ATTACHMENT 3

Marked-up Current
South Texas Project Technical Specifications
Reflecting Proposed Changes
to the
Shutdown Margin Technical Specification

Attachment 3
ST-HL-AE-4222
PAGE 1 OF 4

FIGURE 3.1-1
REQUIRED SHUTDOWN MARGIN VERSUS RCS CRITICAL BORON CONCENTRATION
(MODES 1, 2, 3, AND 4)

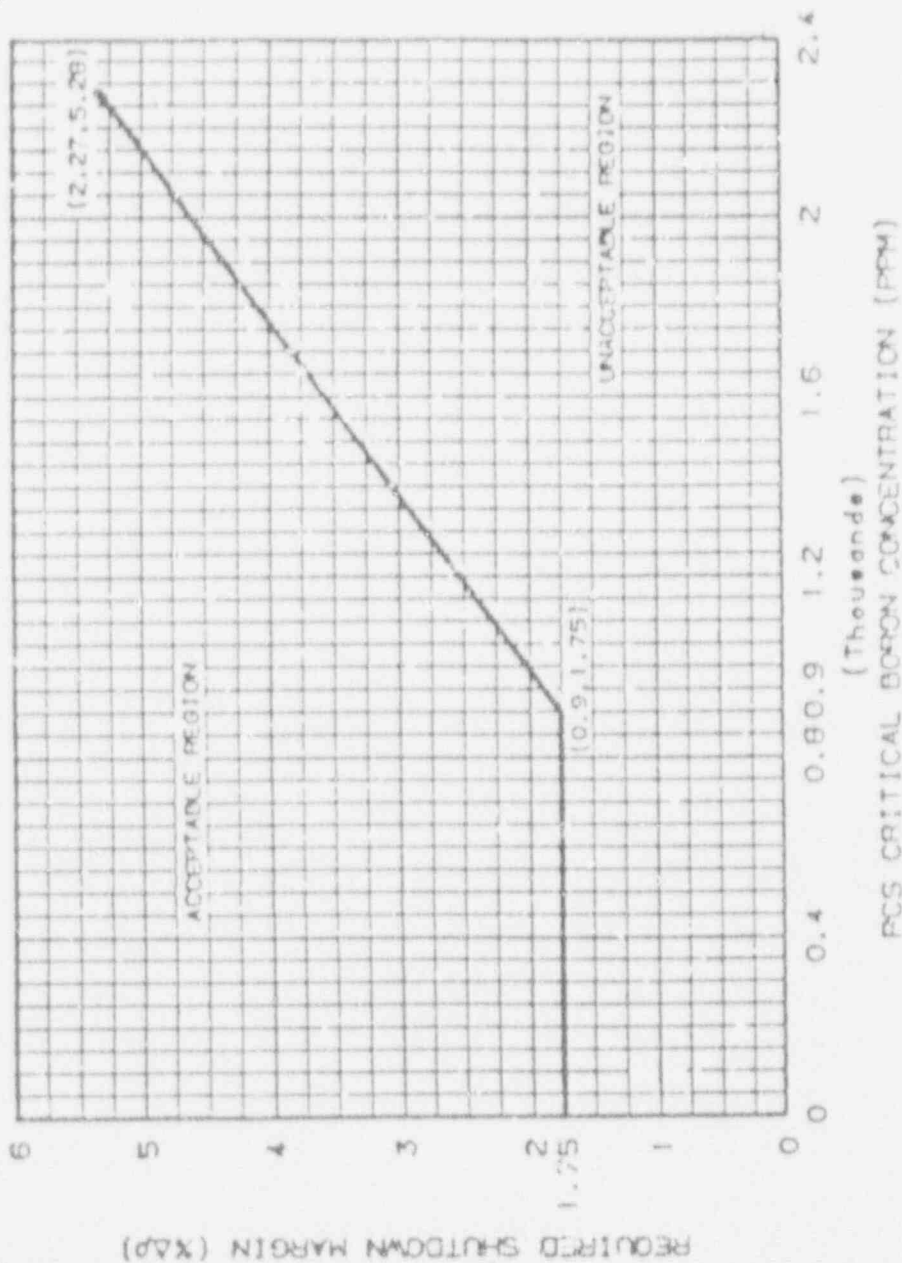
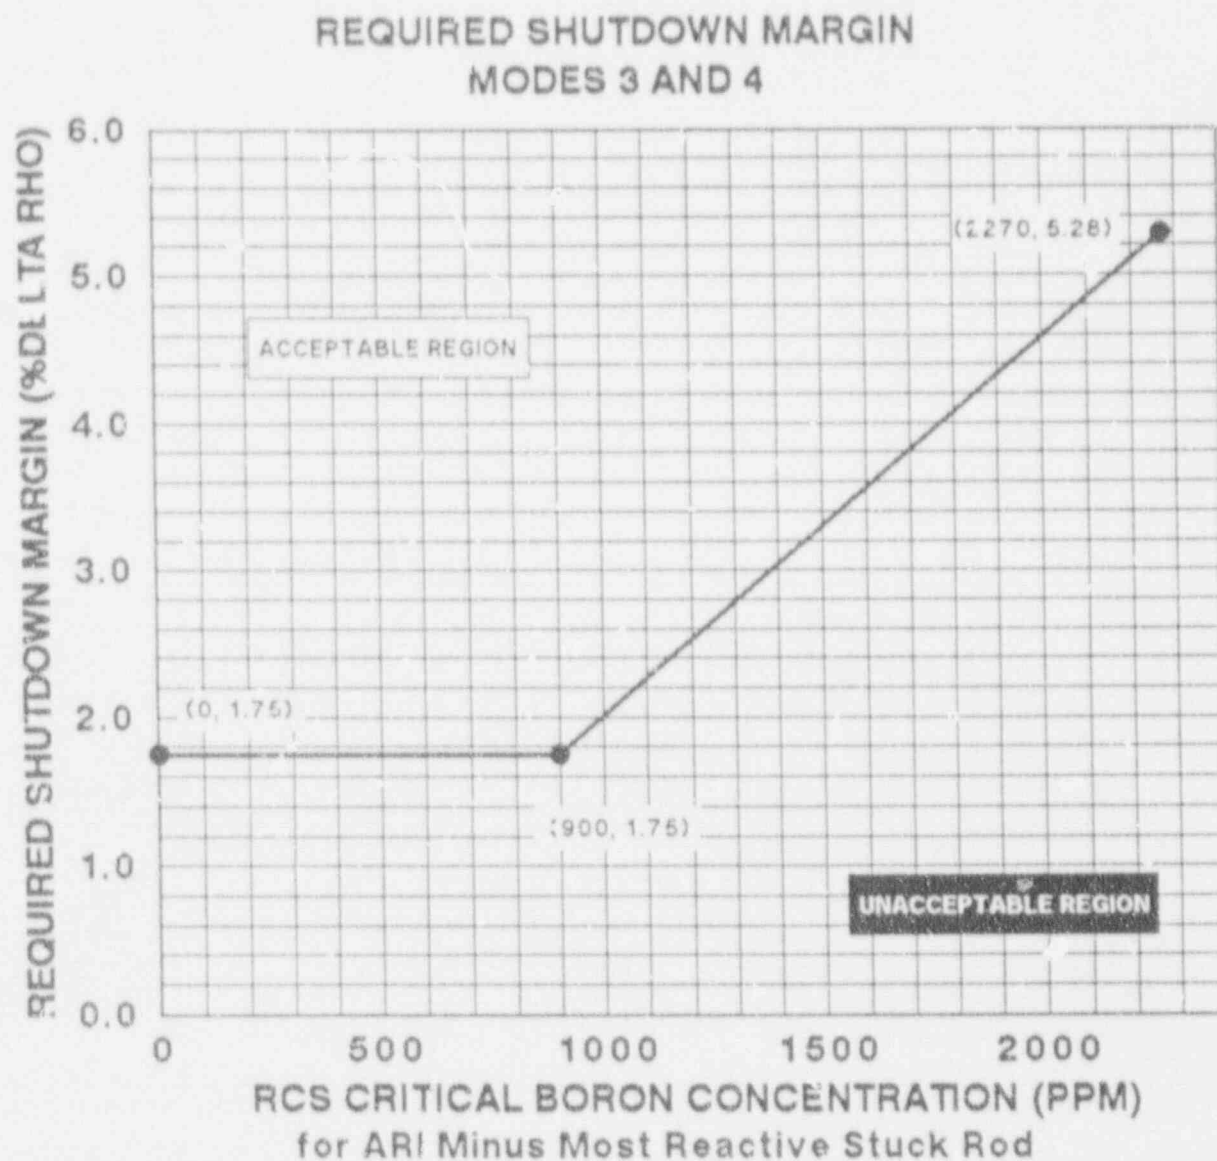
REPLACE WITH NEXT PAGE

REQUIRED SHUTDOWN MARGIN
FOR MODES 1 AND 2:
1.75% DELTA RHO
